KUDZ ZE KAYAH PROJECT

RESPONSE #3 TO YESAB EXECUTIVE COMMITTEE INFORMATION REQUEST KZK

June 2018

**FIGURE 8-2
EXTENT OF DUST DEPOSITION
DURING CONSTRUCTION
(WORST CASE)**

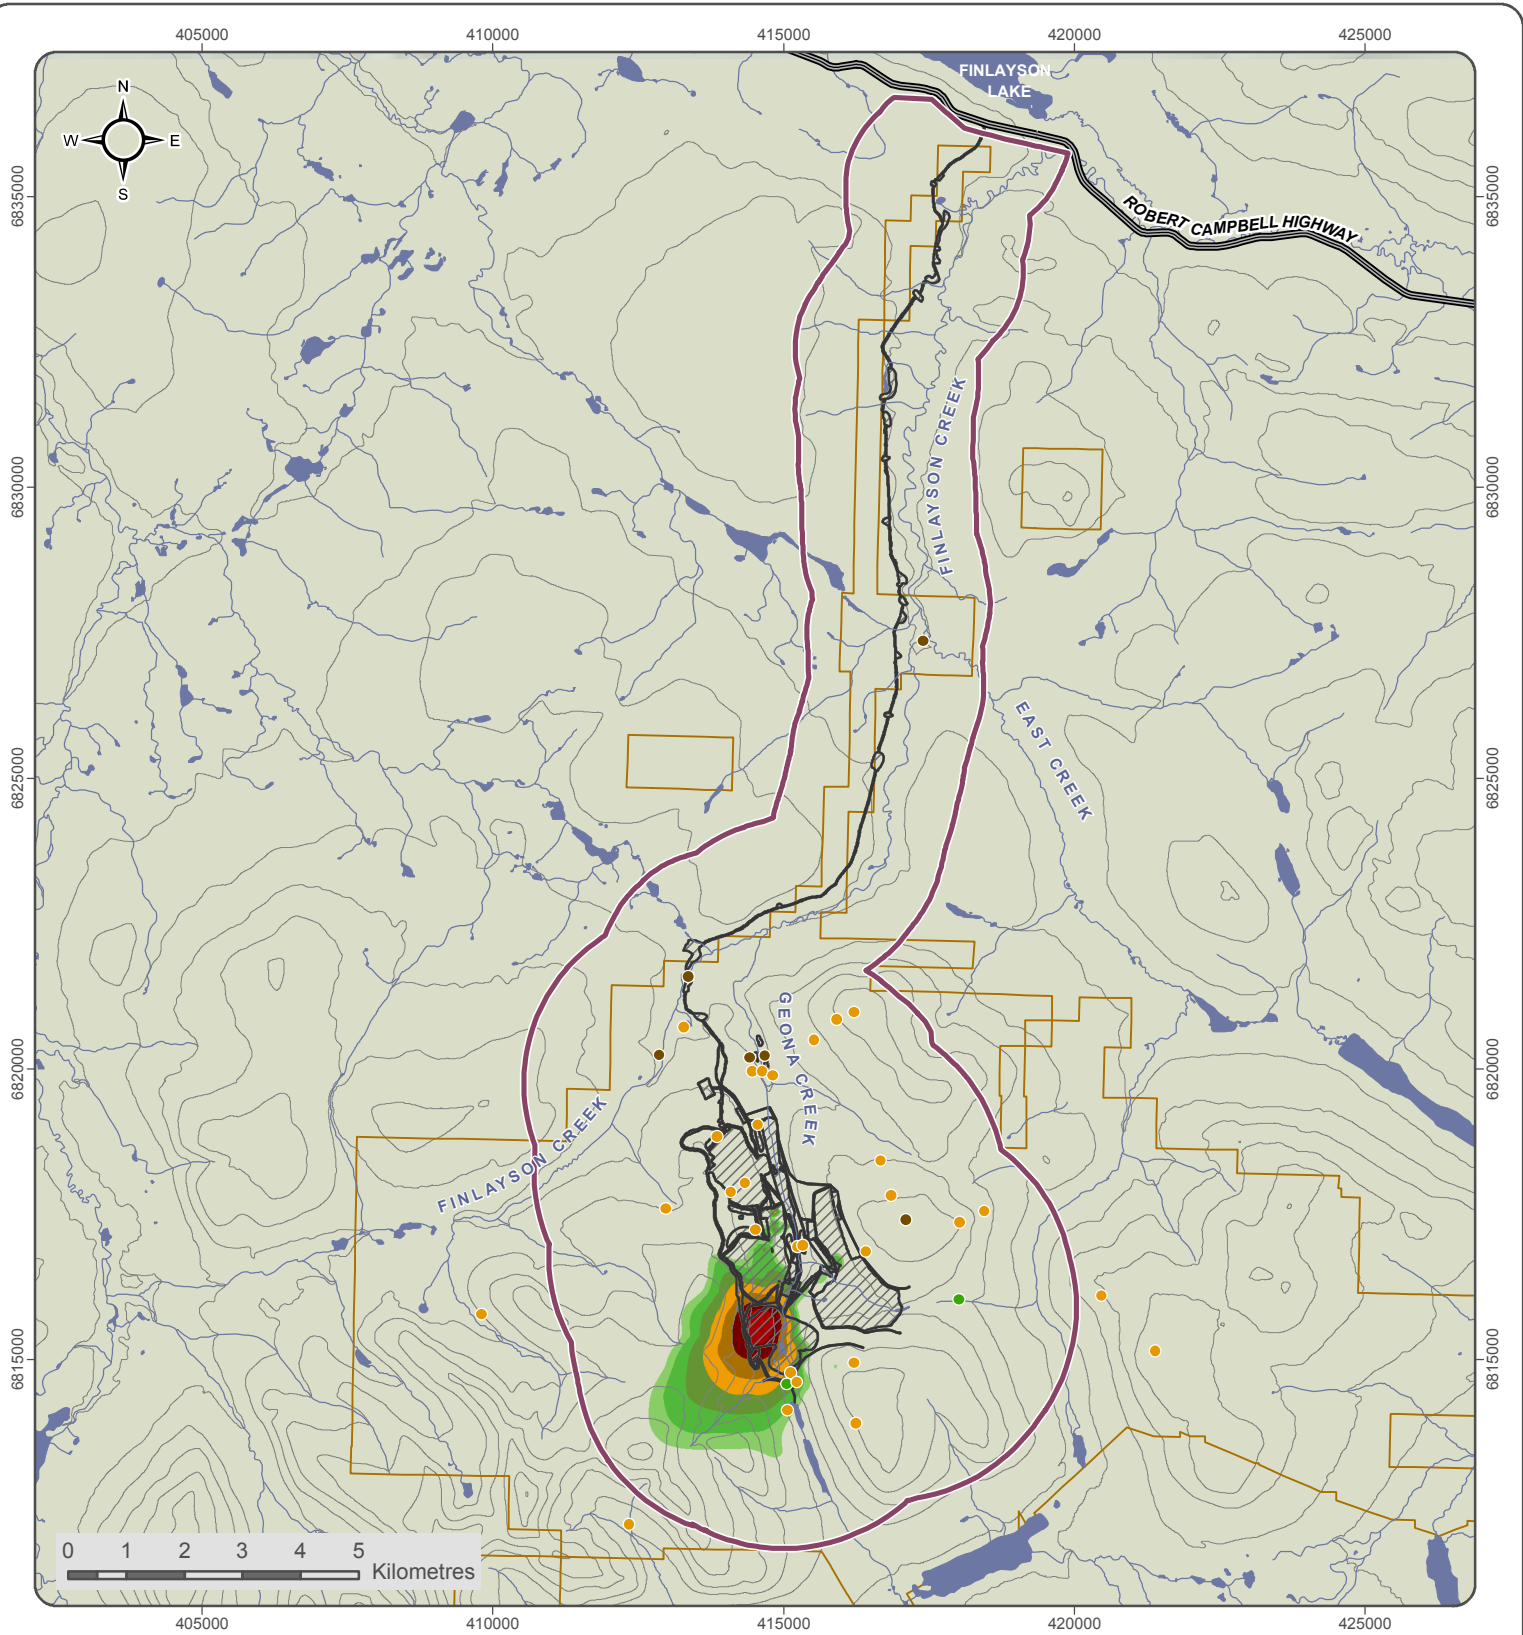
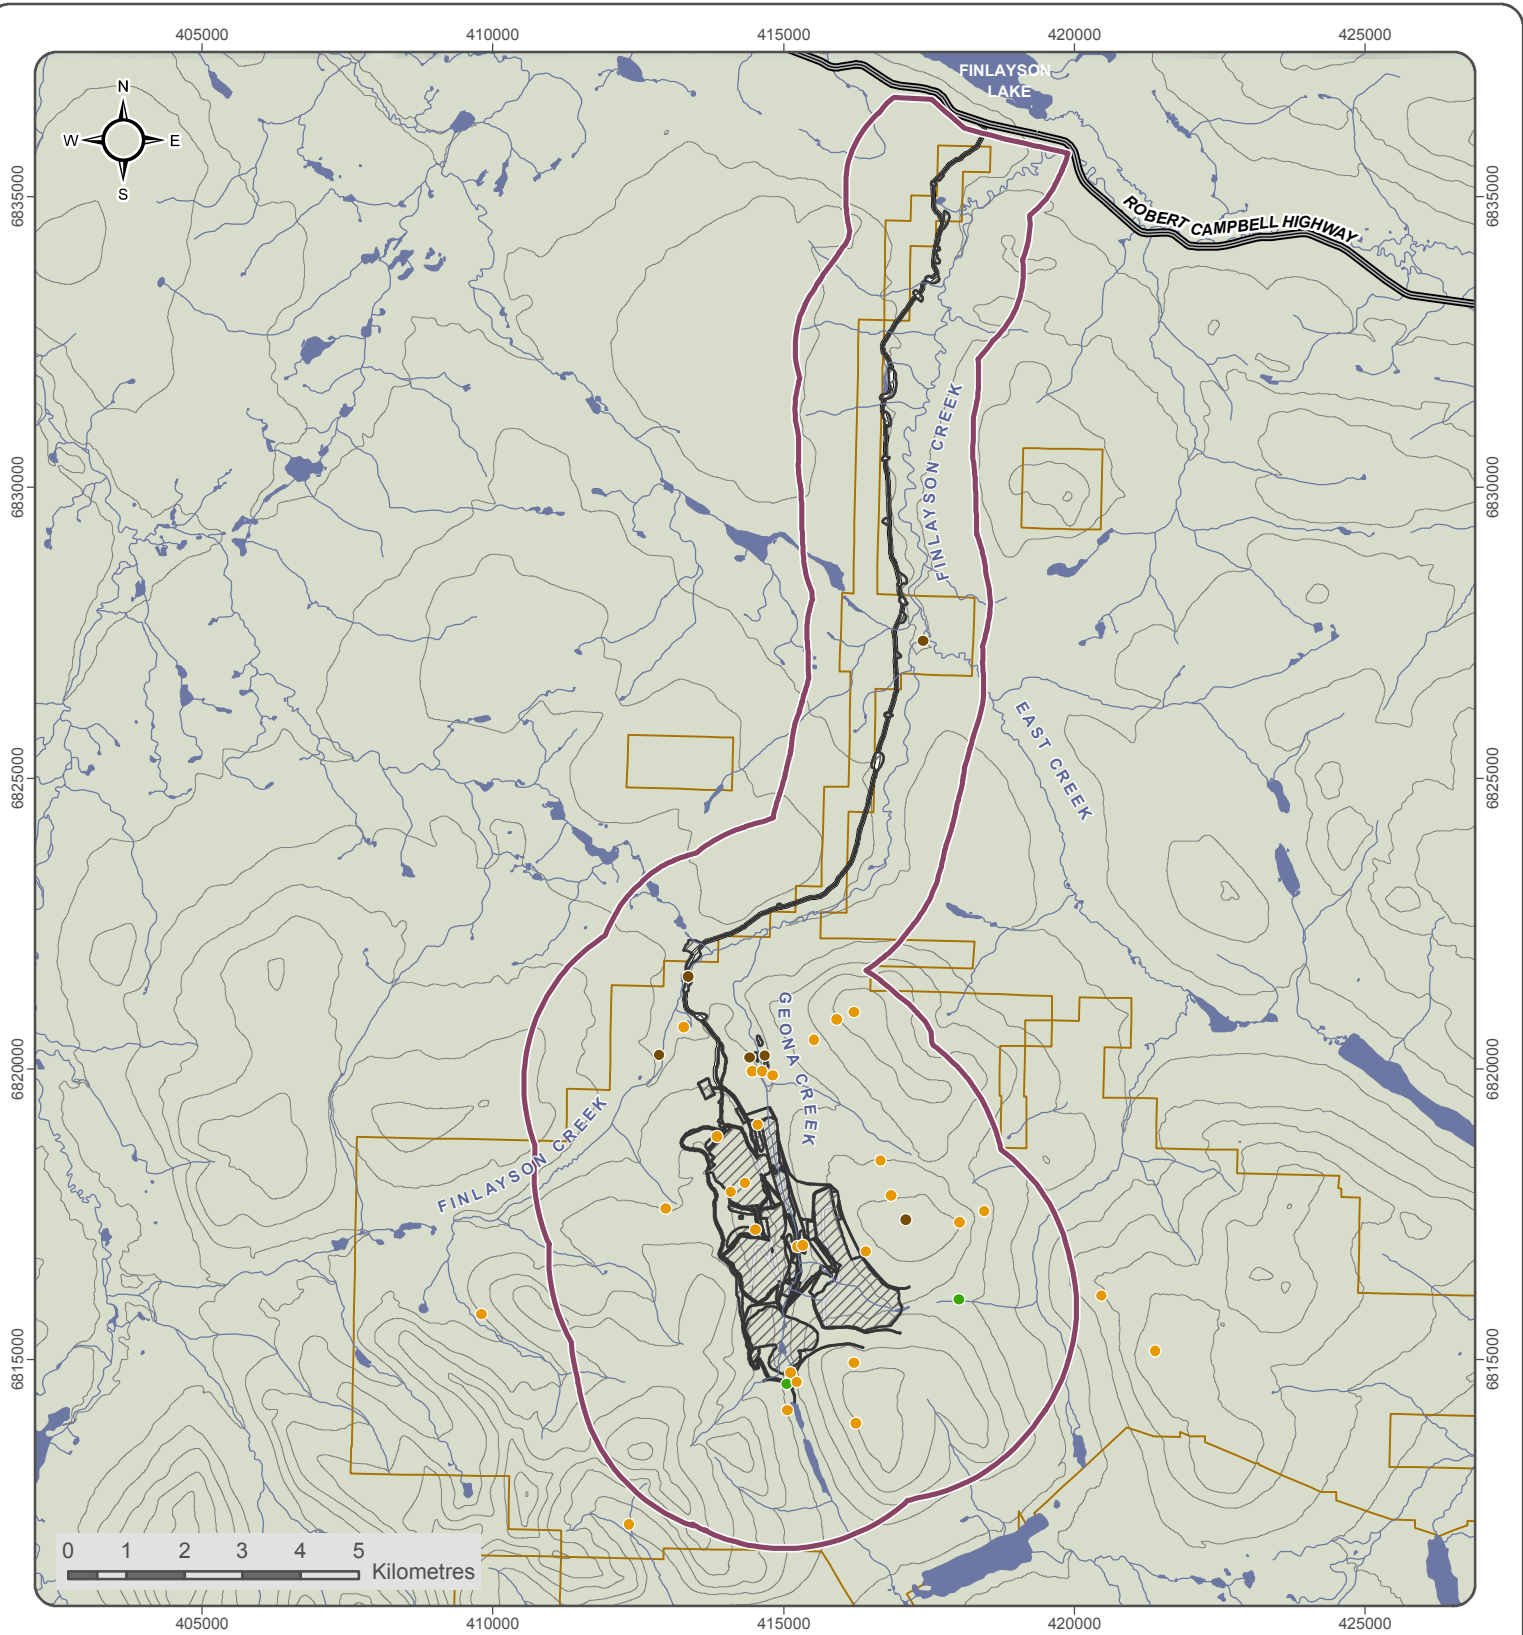
In addition to the results presented in response to R3-24 above for operations, average annual TSP deposition rates were also modeled and mapped for the worst case scenario for construction and closure and are presented in Figure 8-2 and Figure 8-3 below. The figures show contours of predicted annual average deposition rates. The only difference in the model between the Project phases is location, area and/or intensity of dust sources, the meteorological data input and other modeling parameters were kept the same for the three runs. The results show that the main factor affecting ambient air concentrations and deposition rates is whether or not there is blasting occurring in the open pit. The amount, frequency and type of traffic on unpaved roads also varies considerably between Project phases and deposition rates results along roads vary accordingly. Details on dust sources modeled for each Project phase are available in the Air Dispersion Model Report (Appendix E-1 of the Project Proposal).

**FIGURE 8-4
EXTENT OF DUST DEPOSITION
DURING OPERATIONS
(REALISTIC CASE)**

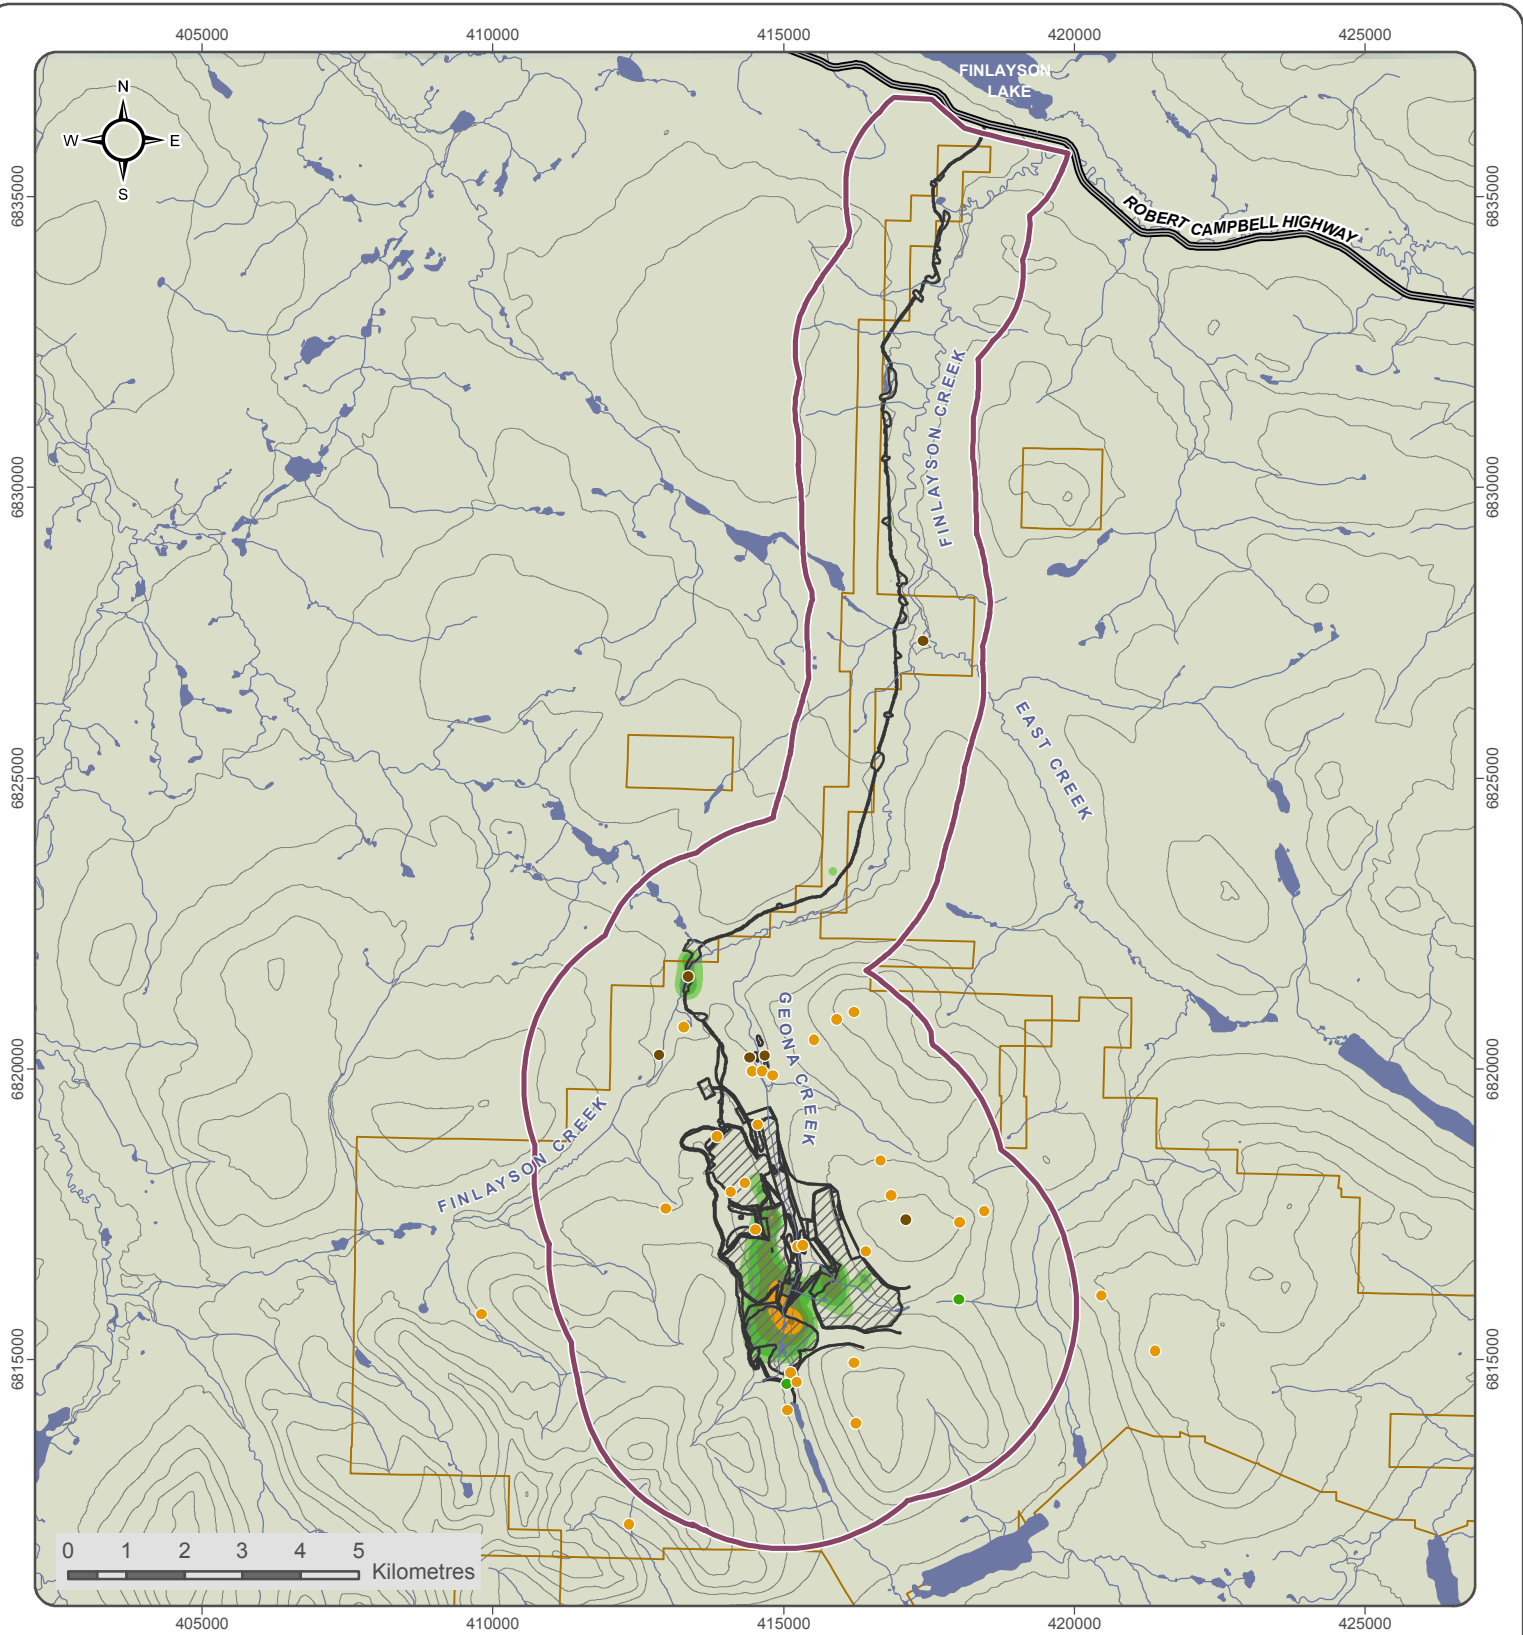
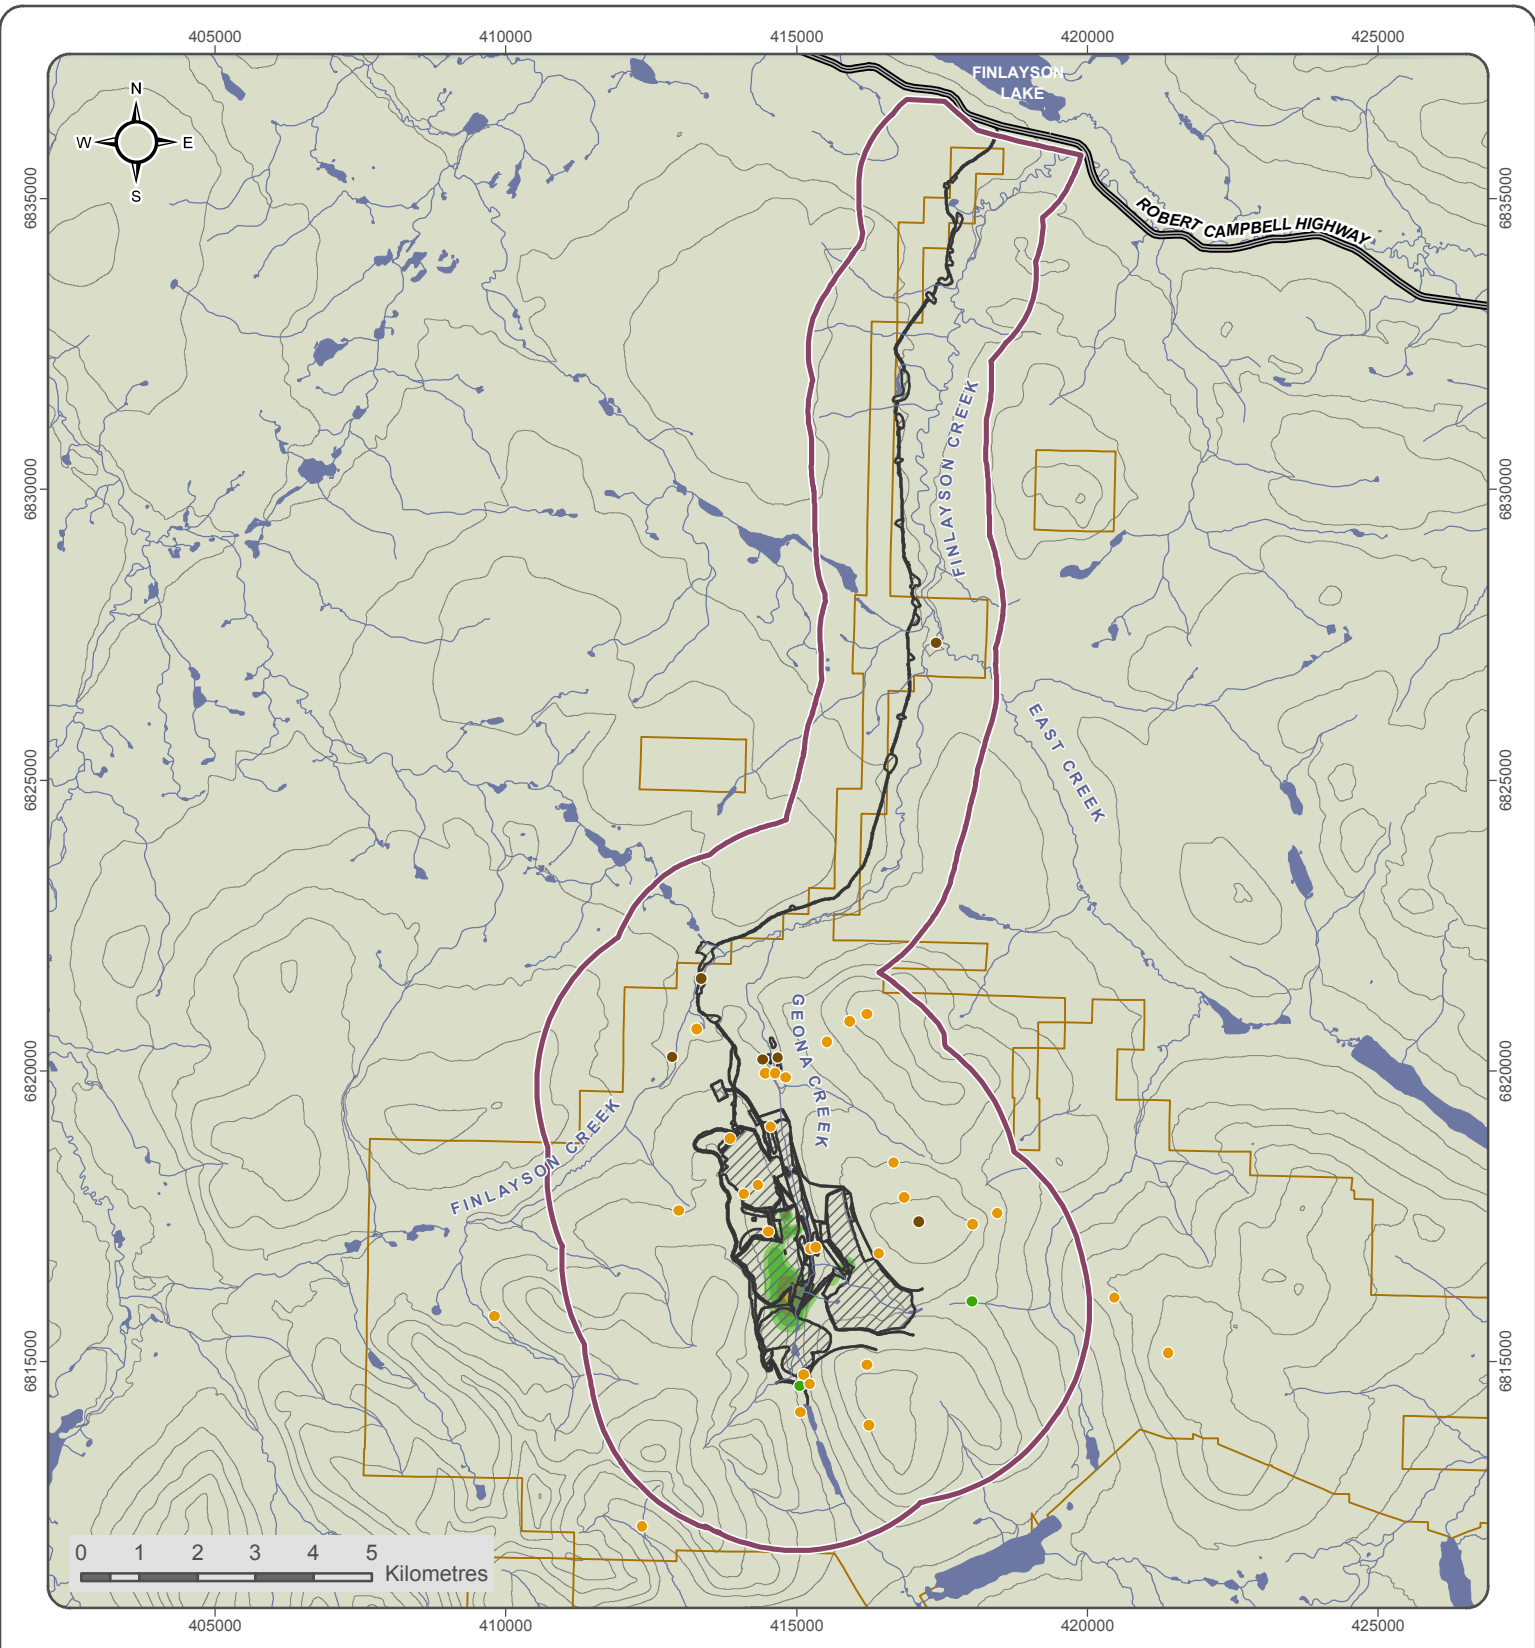
Resulting deposition rates for the realistic case for the operations phase is shown in Figure 8-4. Although not representative of long term accumulation, maximum 24-hr ranked results are compared in Table 8-3 for the worst case (original model run) and realistic case (model rerun) blasting parameters. It shows that by changing the blasting emission factor to account for moisture content and for a greater blasting depth, and changing how the factor is applied to the area (2,500 m² at a time), resulting deposition rates are considerably reduced (by a factor of 2.6 to 3.7 for the first four ranks).

Similarly, the realistic case was modelled for the construction phase (assuming a blasting depth of 20 m, three blasts per week, a blasting area of 1,500 m² and the same moisture content as above) and the results are presented in Figure 8-5, showing considerably reduced deposition rates compared to the worst-case scenario.
